Supplementary Information

Subject: Additional Information – Agenda item 4.1 DA 59362/2020 - 114 Oceano Street, Copacabana - Alterations and Additions to the existing dwelling, removal of three trees on the site and a proposed attached garage

Date: 7 April 2021

SURVEY DETAIL

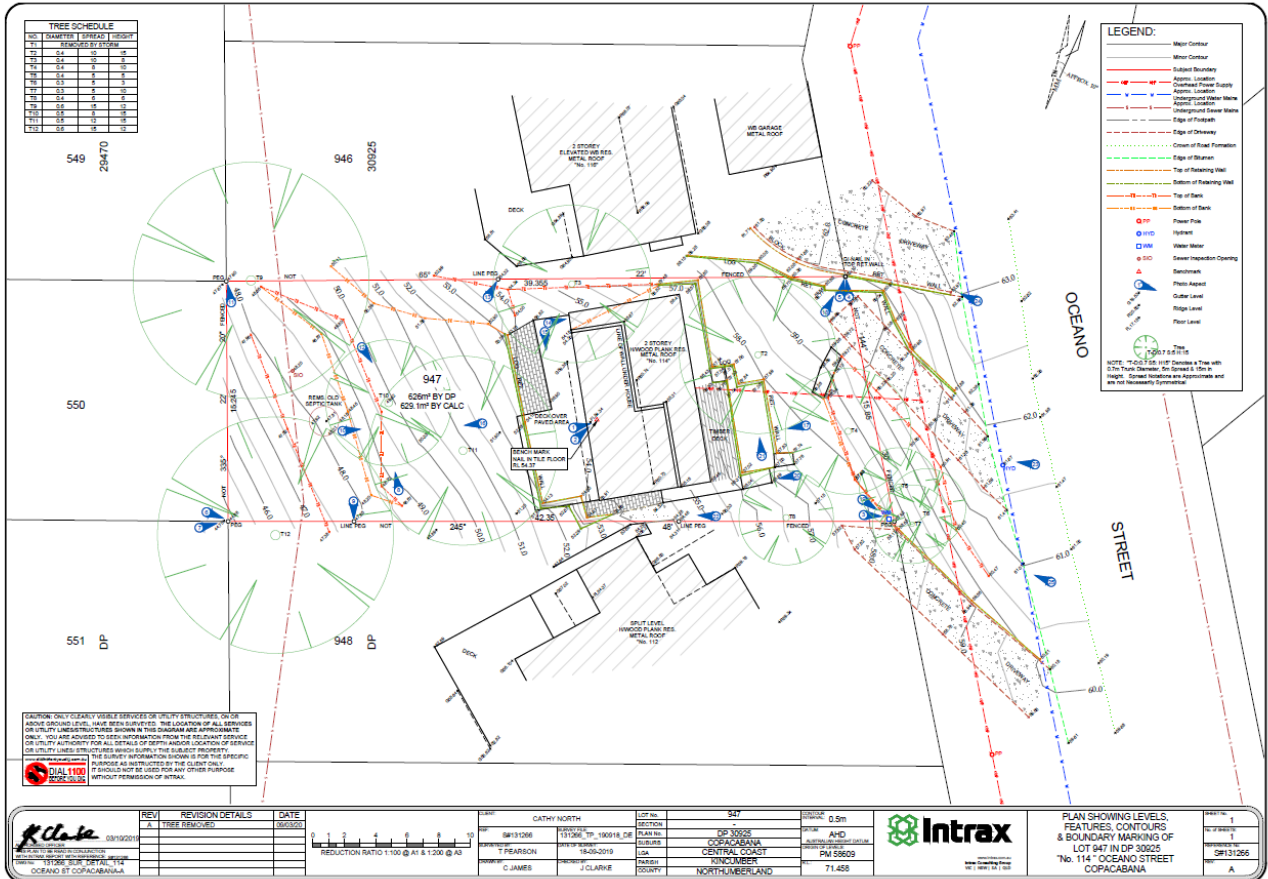
- Confirm the road property boundary relative to site works

The applicant provided a survey diagram prepared by Intrax Consulting Group at the time of making the development application as included below. The survey represents the garage at No. 116 Oceano (lot 946) as positioned on the road property boundary. The survey also refers to the pinning of the corners of the property boundaries with G.I. nails. These nails were present at my site assessment and analysis. I was confident that the boundaries as contained within the site plan are an accurate representation of the actual site boundaries and their location to geographical features surrounding in the area. The applicant also included architectural details with the development application and the site plan on the drawing (referred to as Layout 5), represents the proposed garage at 114 to also be on the road alignment boundary.

SITE PLAN

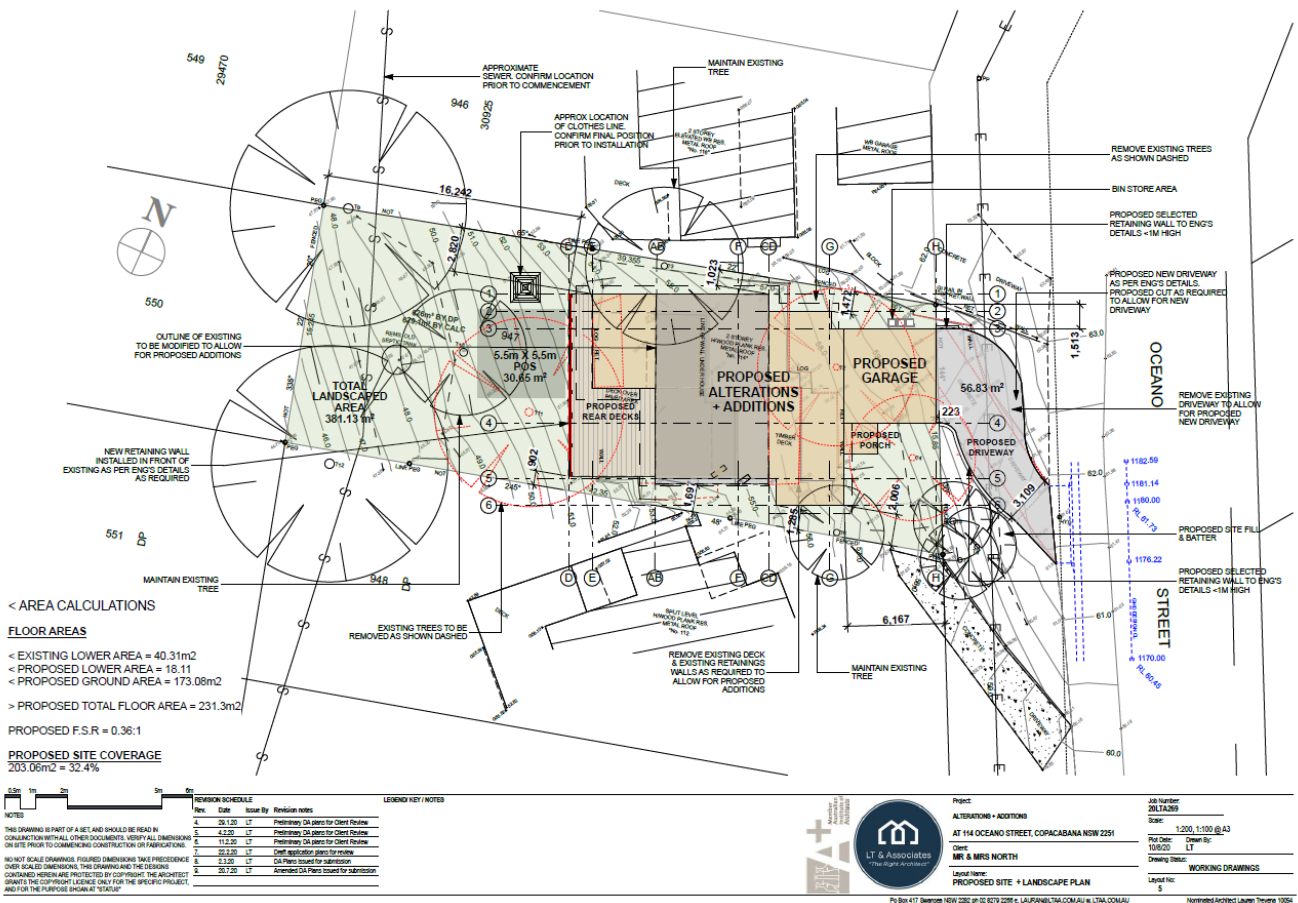
- The site plan in attachment 3 to the report indicates that the proposed garage (to be on the boundary) is in alignment with the existing garage on the property next door (116) – right?.

Yes.
